No. 2024/35/CE-III/BR/Safety(E-3471085)

Sub: Review of Outcome of Third Party Audit of Railway Bridge/ROBs/FOBs

Sub: Technical Report on repeated failure of vertical in 91.5M K Type truss of Bridge no-57 (Down) in Kharagpur Division of S. E. Rly.

**TECHNICAL REPORT ON FAILURE OF
BRIDGE NO. 57 OF S.E. RAILWAY**

2nd vertical U_1M_1 (upper)

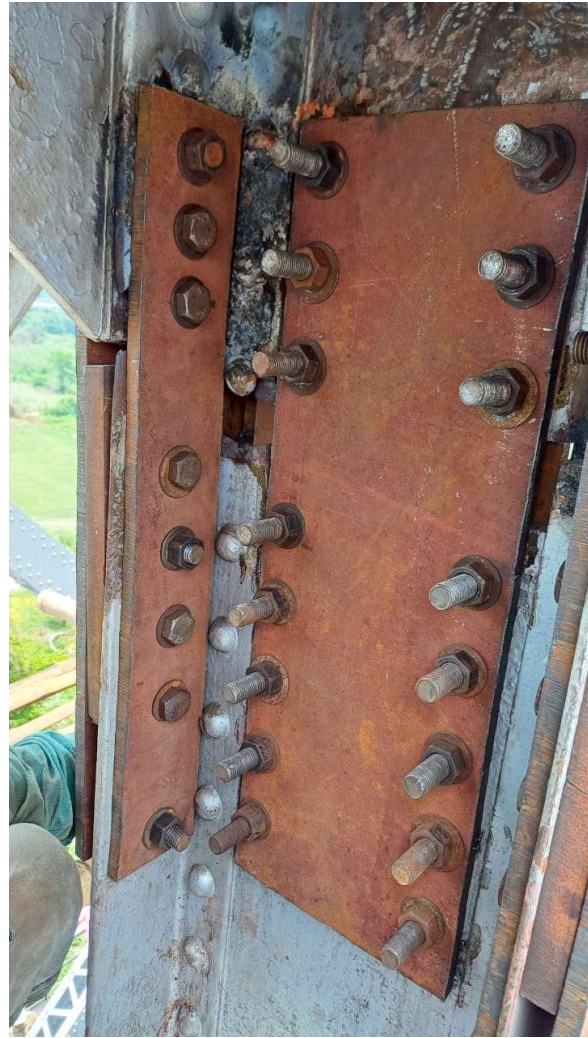
3.0 Cracks were noticed in the 2nd vertical U_1M_1 (upper) at the joint ' U_1 ' of span no.5 of 300feet girder by Sri Prasenjit, BRI staff under SSE/Br/KIG /SER at about 13:00 hours.Immediately 20kmph was imposed.The details are as shown:-

GAP OF 65mm OCCURRED IN THE VERTICAL

WARPING OBSERVED IN THE WEB

CRACKS AT JOINT "U1"

DISTORTION IN THE TOP CHORD MEMBER

SEPARATION OBSERVED IN VERTICAL

WARPING IN TOP CHORD WEB/ANGLE

4.0 Strengthening done immediately on 17.05.2024 by temporary splicing. The details are as follows:-

REPAIRING DONE BY SPLICING AND BOLTING

Fig.1: Full crack near U1 Node in the line of the last rivet (from Top) in Vertical & Gusset Connection.

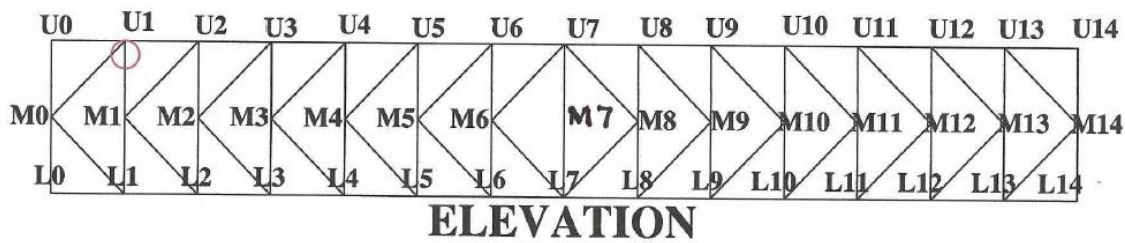
2.1 SER vide letter No. BR/CBE Cell/ dated 21.05.2014 reported structural distress in the Bridge No 57 DN. Cracks were noticed on Second Vertical U1M1(Upper) near U1 of span no. 5 (91.4m span) by BRI staff on 17.05.2024. A gap of approximately 65mm was reported at the location of crack in U1M1.
